1959 Corvette: Service Bulletin: Windshield Washers

SUBJECT: 1959 PASSENGER CAR
WINDSHIELD WASHERS

BULLETIN No. DR #405

March 18, 1959

FIG. #1

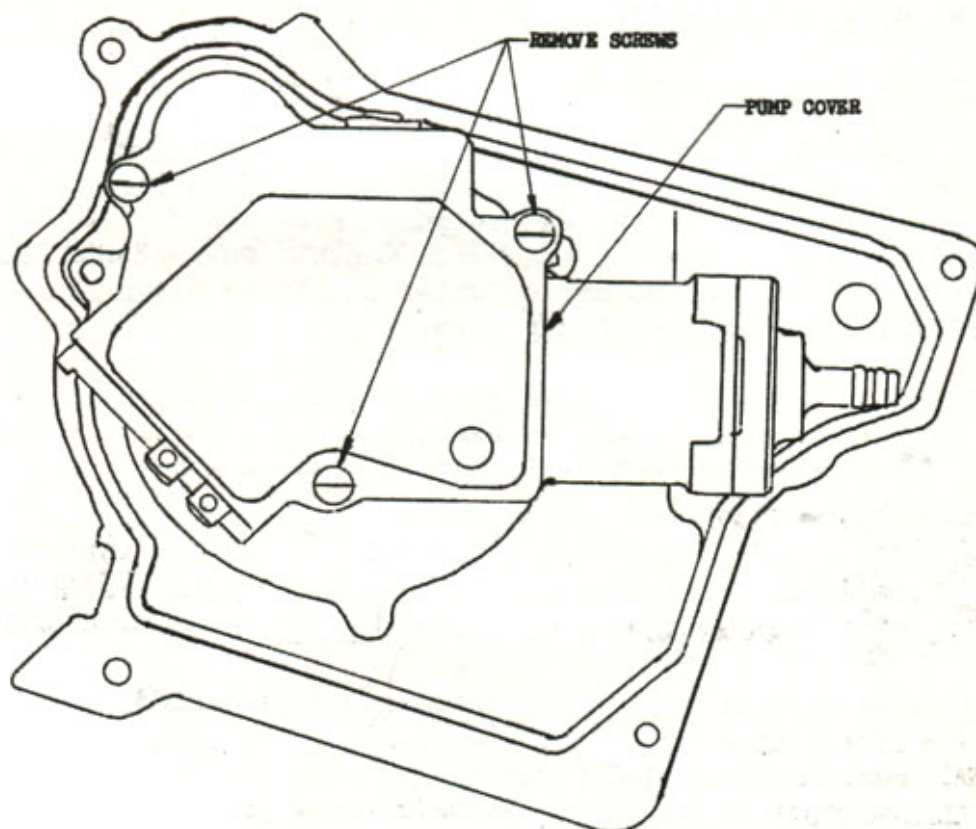
1. Remove pump cover. Cover is retained by three (3) screws. See Figure #1.
2. Lift terminal board up.
3. Pull relay out of pump body. Relay is retained by clip. Relay, armature and terminal board will come out together. See Figure #2.
4. Reinstall new Relay and Terminal Board Assembly, #4906055.

ARMATURE - LATE DESIGN
FIG. #4

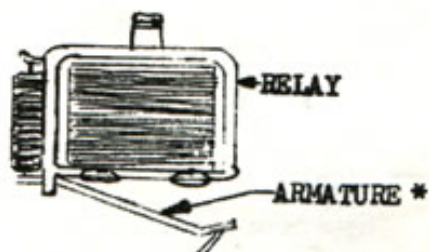
A few very early units may have a relay armature with a small opening or window which may contact the drive pawl. This could allow the drive pawl to push the armature up out of the park position and allow unit to recycle. Later armatures had a wider window and also a notch at end that contacts nylon gear. This notch prevented the drive pawl from catching top of ratchet tooth which also may cause unit to recycle. Later armatures incorporated additional features to maintain free movement and assume proper stop.

NOTE: See Figure #4, examples of early and late armature.

CORRECTION: Replace Relay and Terminal Board Assembly, #4906055 (late type armature is part of this assembly).

FIG. #6

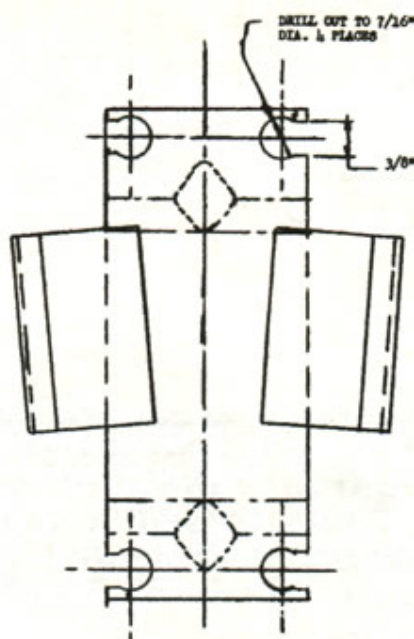
2. Drill out the four attaching holes in washer mounting bracket to 7/16". Cut away out board edge of attaching holes so grommet can be pressed into bracket. See Figure #6.

FIG. #7

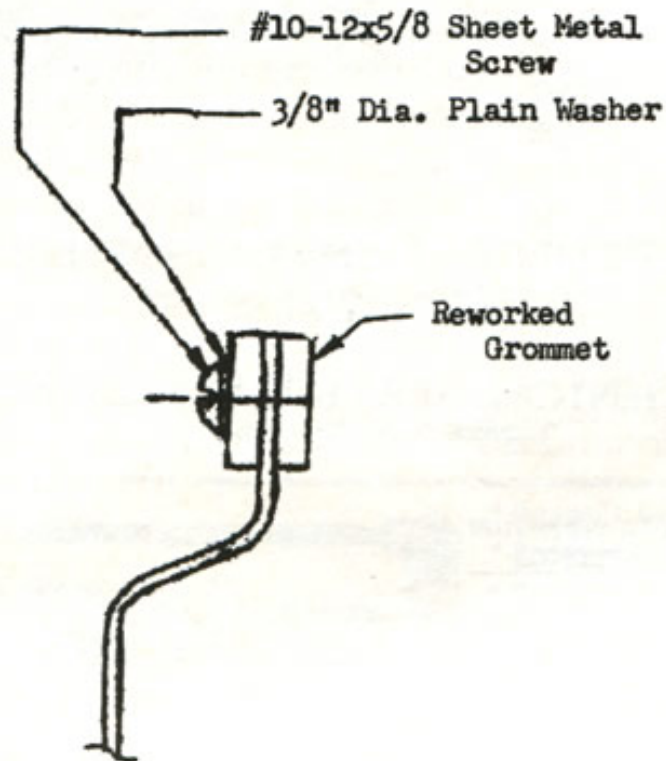
3. Place $\frac{3}{8}$ diameter flat washers on front side of reworked grommets and attach bracket to dash. See Figure #7.
